Access Compliance Report Public Rights-of-Way (Curb Ramps)

Main Street: **OSO_PKWY** Cross Street: **SOLANO** Location: **N**

ADA ID: **RPAT220208111215** Ramp Type: **Type 1 - Perpendicular Diagonal** Initial Pass/Fail: **Fail** Overall Compliance: **No** Severity Score: **2**

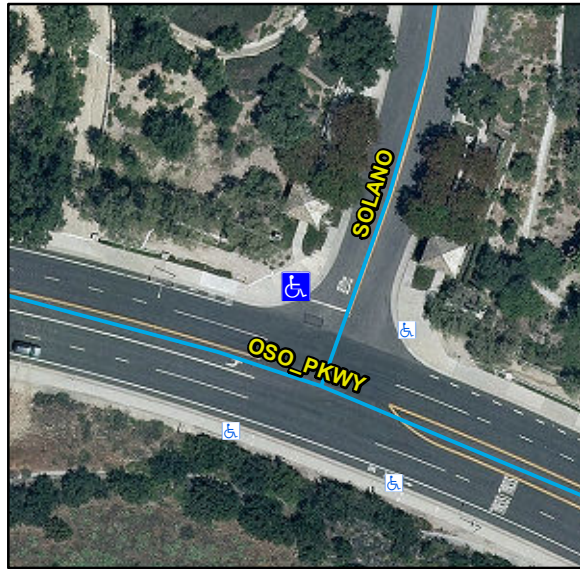
Compliance	Description	Data	Compliance	Description	Data
N/A	Ramp Length (in)	129	N/A	Flare Type LT	
Yes	Ramp Width (in)	48			N/A
Yes	Ramp Run Slope (%)	5.6	N/A	Flare Slope LT (%)	N/A
No	Ramp Cross Slope (%)	3.4	N/A	Flare Traversable LT	N/A
N/A	Landing Present	N/A	N/A	Flare Type RT	
N/A	Landing Length (in)	N/A			N/A
N/A	Landing Width (in)	N/A	N/A	Flare Slope RT (%)	N/A
N/A	Landing Run Slope (%)	N/A	N/A	Flare Traversable RT	N/A
N/A	Landing Cross Slope (%)	N/A	N/A	DWS Provided	N/A
N/A	Landing Movement Obstructed?	N/A	N/A	DWS Contrast	N/A
	Landing Movement Type	N/A	N/A	DWS Length (in)	N/A
N/A	Landing Shared	N/A	N/A	DWS Full Width	N/A
N/A	Clear Space	Yes	N/A	DWS Offset Left (in)	N/A
N/A	Clear Space To Crosswalk (in)	N/A	N/A	DWS Offset Right (in)	N/A
N/A	Marked Crosswalk 1	No	N/A	Marked Crosswalk 2	No
	Crossing 1 Direction	SW		Crossing 2 Direction	SE
	Marked Crosswalk 1 Width (in)	N/A		Marked Crosswalk 2 Width (in)	N/A

N/A	Ramp Inside Crosswalk 1	N/A	Yes	Ramp Inside Crosswalk 2	N/A
	Crossing 1 Slope (%)	5		Crossing 2 Slope (%)	11
	Crossing 1 Cross Slope (%)	1.6		Crossing 2 Cross Slope (%)	0.4
N/A	Gutter Ponding	N/A	No	Curb Slope	9.4
Yes	Gutter Lip Height (in)	0		Road Run Slope (%)	1.2
N/A	Gutter Run Slope (%)	N/A		Road Cross Slope (%)	9.2
N/A	Gutter Cross Slope (%)	N/A			
Yes	Overall Surface Condition: Acceptable		Yes	Perp Joint Present	Yes
	Cross Gutter Present?	No		Spandrel Present?	No
	Replace Cross Gutter?	N/A		Replace Spandrel?	N/A

Remove & Replace Curb Ramp With Two New Directional Ramps or Equivalent.

R304.2.2, R304.5.3, STD 1115
